MARSTON

Re: Planning and Development Act 2000-2021 and the statutory regulations (as amended). Application by EdgeConneX Ireland Limited for development at this site within the townland of Ballymakailly to the west of the R120 (Newcastle Road), Lucan, Co. Dublin. The development will consist of the construction of two no. single storey data centres with associated office and service areas; and three no. two storey gas powered generation plant buildings with an overall gross floor area of 24,624sqm

Reg. Ref. SD21A/0042

ADDITIONAL INFORMATION

Excerpt from Drawing no. 101 submitted by Kevin Fitzpatrick Landscape Architecture showing proposed public access

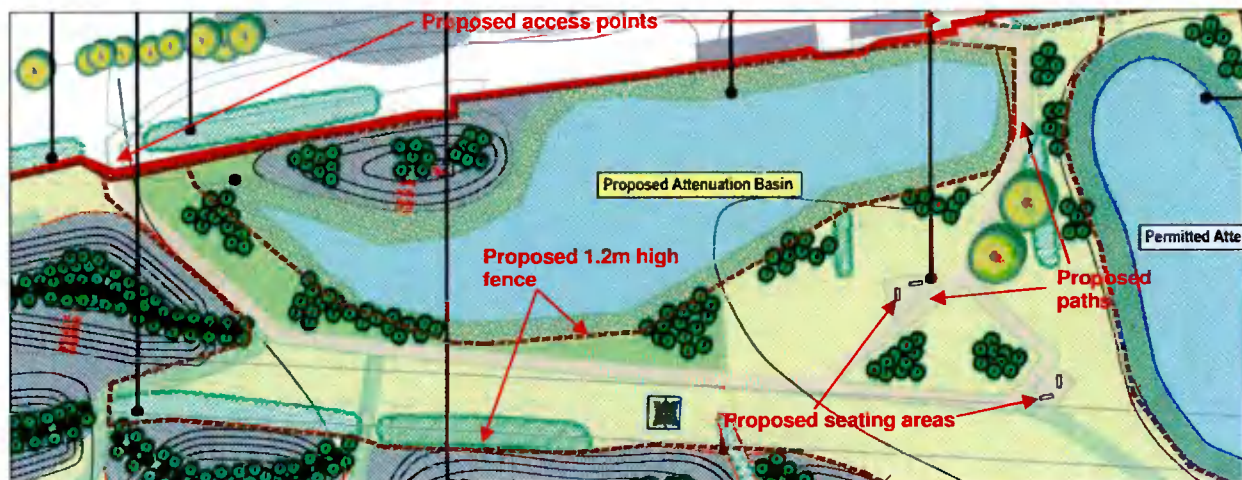
1. RU zoned lands

Further to discussion with both the Planning and the Park Departments of the Council it has been agreed to provide controlled access to a portion of the RU zoned land along the northern / Grand Canal side of the site. We propose to provide two access points to the west and east of the new attenuation pond. A new public path will connect the RU zoned land with the existing canal towpath to facilitate access to the new wetland and woodland habitat that will be created by the implementation of the 2019 permission and new attenuation pond proposed in this instance (Please refer to Drawing no. 101 submitted by Kevin Fitzpatrick Landscape Architecture – see below with additional notes for clarity).

Access is controlled to avoid uncontrolled access to the attenuation ponds and the wider landscaped RU zoned lands by a 1.2m high timber post and rail fence (brown dashed line). It is proposed to create two seating areas that will overlook the wetland habitats that will be created by the permitted and proposed attenuation ponds.

The access points to the RU zoned lands will be opened up by the applicant / operator of the proposed development in a similar manner to a public park at 10am-4pm during the winter months and from 8am – 7pm during the summer months. The provision of such public access fully conforms to Policy ET3 SLO1 and ET6 Objective 1 of the County Development in providing and improving public amenity along the canal.

Front elevation of abandoned dwelling

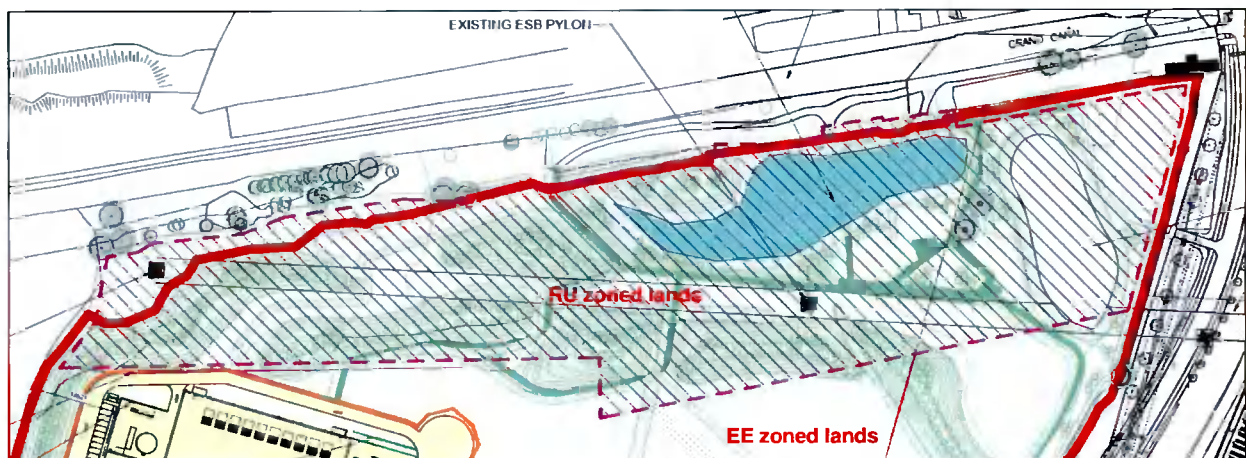
Demolition of existing dwelling

The existing dwelling to be demolished is in extremely poor condition and has not been in residential use for a number of years. Its abandonment has led to it being in a ruinous state prior to our clients taking over the

ownership of the land. We respectfully submit that the aim of achieving public access to the lands runs at cross purposes with seeking to retain, and in this instance refurbishing this house of no architectural merit or quality. Its removal will have a positive impact both on the amenity of the canal but also on the attractiveness of providing public access to the RU zoned lands and in providing further access along the southern side of the canal in the future.

Aerial view of application site with application boundary shown outside application site for clarity purposes to show existing green infrastructure

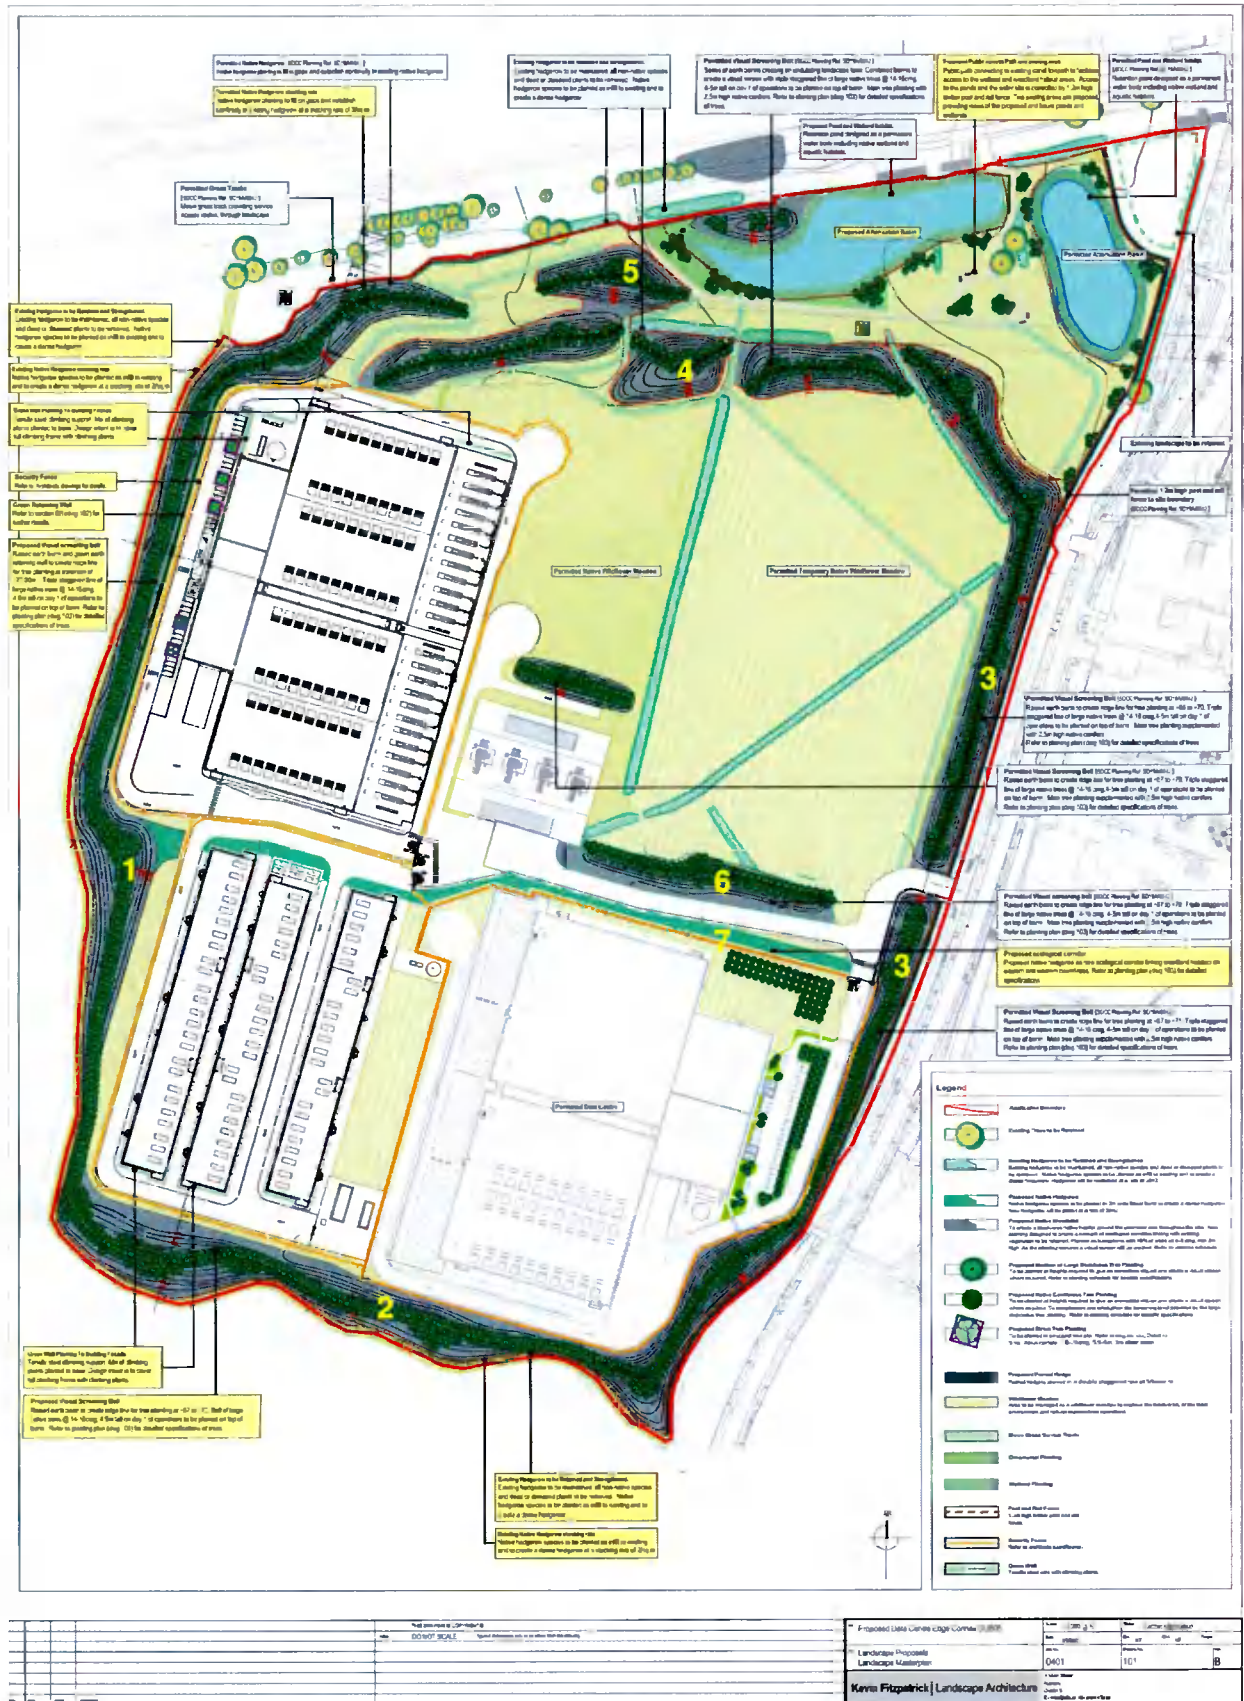
15. Ecological connections

We respectfully submit that there is a need to consider any removal in the context of the overall proposal and landscaping being proposed. The existing site prior to development contains c. 2,480m of hedgerows and tree lines that are located along the southern and western boundary; which form part of the northern boundary of the site and around properties along this northern boundary as well as boundaries around fields that are formed by the three linear hedgerows that run in north to south and north-east to south-west direction across the centre of the site. These hedgerows link into the green infrastructure to the north of the site and to the canal.

The current proposal seeks to remove c. 390m of this hedgerow as shown on the previous page (shaded yellow) with c. 250m having been lost under the 2019 application and permission (shaded purple). This amounts to a c. 640m loss overall that has been mitigated through carefully considered landscape design and planting. Substantial mitigation and augmentation measures are already proposed and permitted around the site. This includes the following:
